CHANGE NOTE

Project Name	MH6
Base Model	LMX120BMW
Variant Model	LMX120HN
HW Version	Rev.A
Issue Date

ADD LTE BAND 12 for X120HN model	
	1. Only change SW, enable LTE B12. 2. No need change by HW components. 3. Recognition of Single and Double Cards: -Software achieves this function through BoardID recognition -Hardware achieves this function through card slot

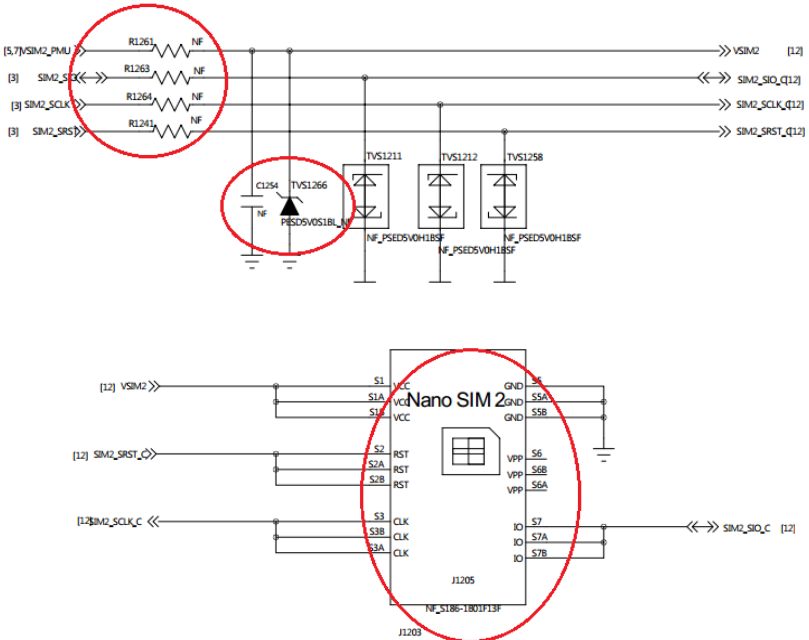
LMX120BMW: Dual SIM

LMX120HN: Single SIM
